## SANDY CITY COMMUNITY DEVELOPMENT

## **MEMORANDUM**

**Subject:** Bell Canyon Cove Subdivision (Prelim Review)

SUB-02-20-5803

11400 SOUTH ROAD CROSS SECTION

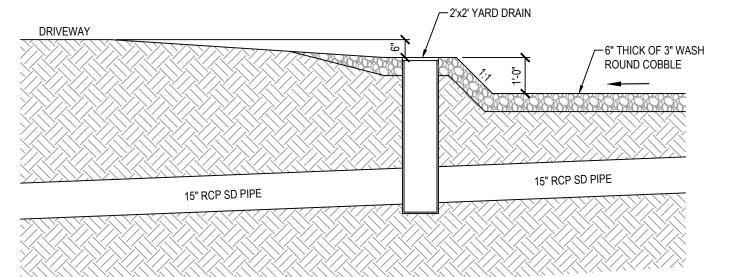
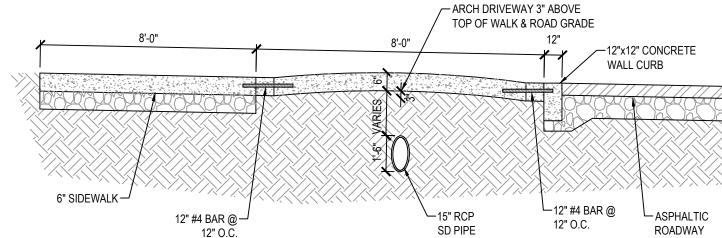
The pavement width will be 26 feet and the road will conform to fire access requirements. The City Engineer is recommending the exception because less grading associated with cuts and fills will be required. Storm water will be also be treated on site rather than in the traditional manner. <u>Staff and the City Engineer **support** this request.</u>

There will be an 8 foot parkstrip on the west side of the new street that incorporates a drainage swale, in addition to an 8 foot sidewalk. The City Engineer recommends the exception due to the LID (low impact development) drainage swale being proposed, and the use of a constant sloping road draining into the swale, as opposed to a crowned road. The inclusion of sidewalk and parkstrip on only one side of the road will also contribute to the rural feel of the area. Staff and the City Engineer support this request.

3. It is noteworthy that the proposed subdivision does not include sidewalk along the east side of the right-of-way. The absence of sidewalk is detrimental to the walkability of the area. However, its absence is conducive to the rural feel of the area, and similar proposals have previously been approved for similar subdivisions, such as Quail Crest, for example. It will also provide a benefit by using LID principles to handle drainage. There will also be less grading impact associated with fewer cuts and fills.

- 2. Exception for a public right-of-way less than 52 feet The ROW as designed per the plans was designed in conjunction with Sandy City Staff. This enhances the rural feel, it incorporates low impact development (LID) principles and is a new cross section the City asked us to design.

- 3. Exception for a waiver to the requirement for gutter, park strip, and sidewalk on both sides of the street The response to this exception would be the same as we provided for #2. The cross section as designed is in cooperation to Sandy City staff recommendations. The rural feel and LID benefits are bonuses to this cross section.

CONCEPTUAL MASTER PLAN

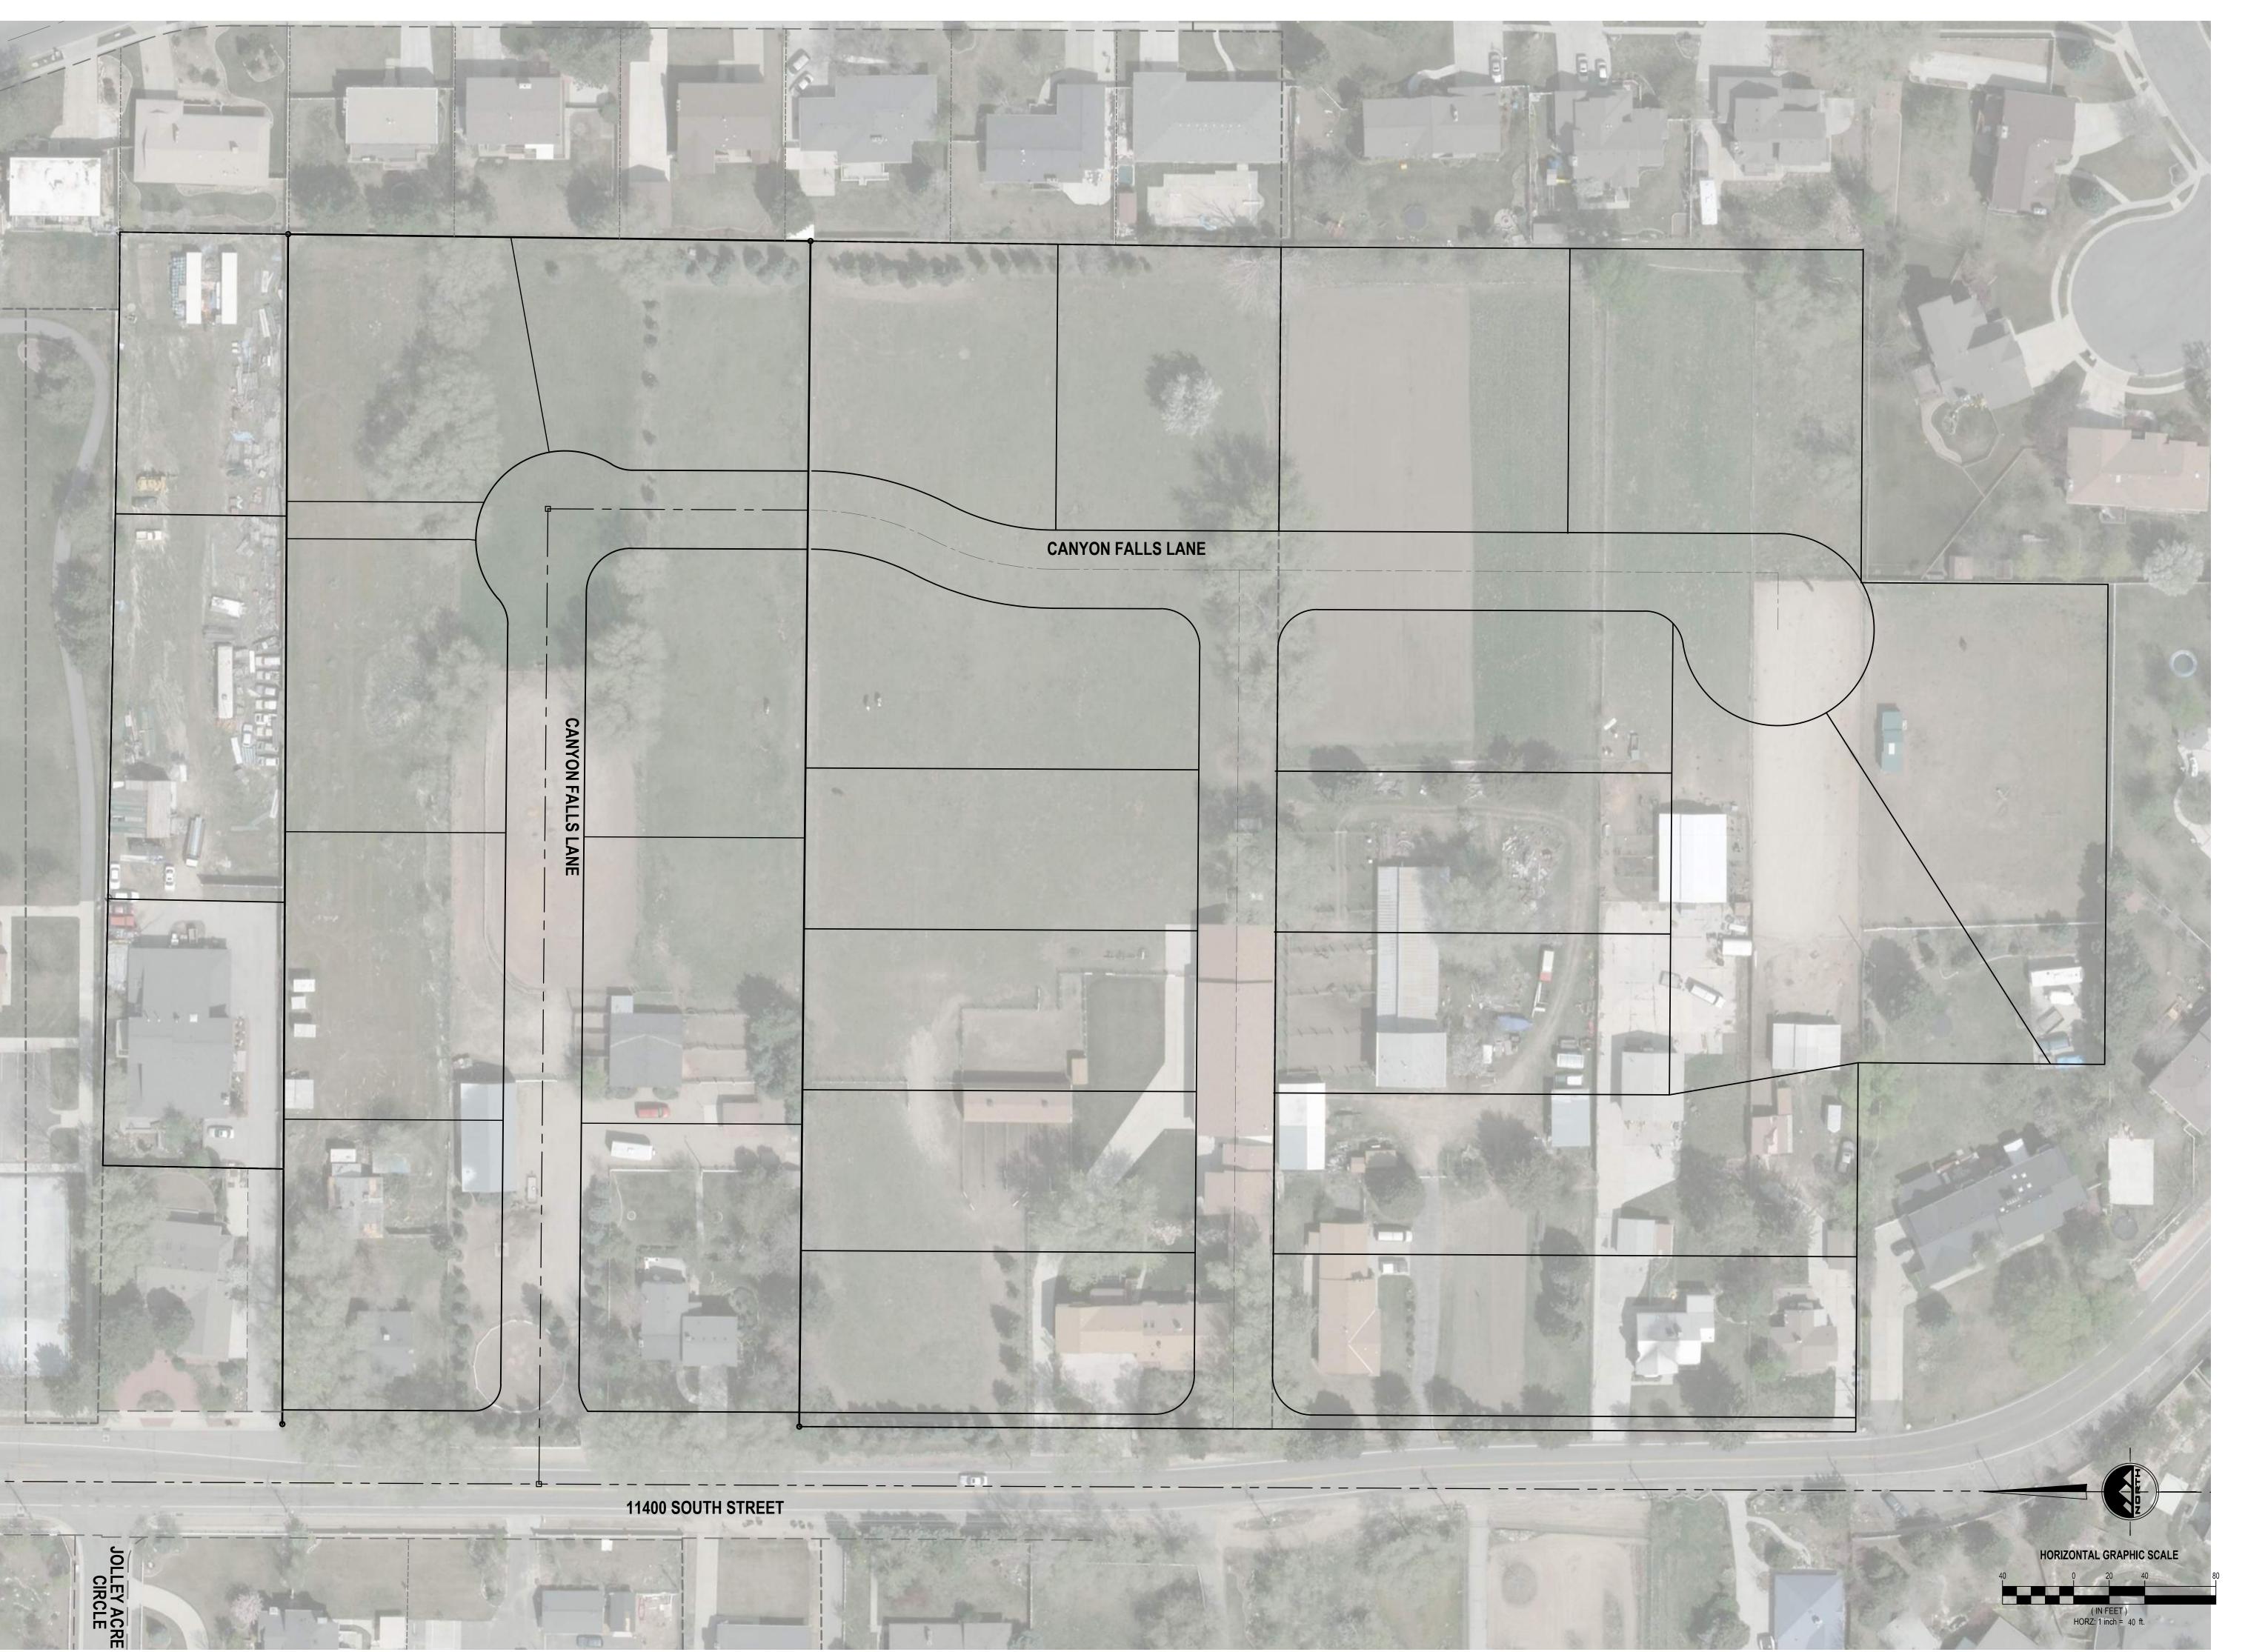
- 1. Staff is concerned with master planning of the surrounding area. The subdivision, as proposed, leaves out the property immediately to the east and to the west of this development.

- b. The property to the west, specifically Lot 2 of the Park Lane subdivision, is anticipated to develop at some point, but will not be able to connect to this subdivision using a public road. The applicant's proposal includes a 'Parcel A' on the west side that is 21 feet wide and is intended to provide private access to that property. The applicant has provided a master plan showing a potential development configuration and has also added a plat note showing that this private access will be owned and maintained by Lot 2 of the Park Lane Subdivision. The 21 foot width is wide enough for a private access by City standards.

- 2. The master plan provided by the applicant shows an additional two lots on the Fluekiger property to the west. It is important to note that this property will have to be rezoned or have a Land Development Code text amendment done to allow the extra lots. Likewise, the property to the east is depicted with potential half acre lots. This property is currently part

of the County and would need to be annexed into Sandy City. It will then need to be rezoned if it is to allow half acre lots.
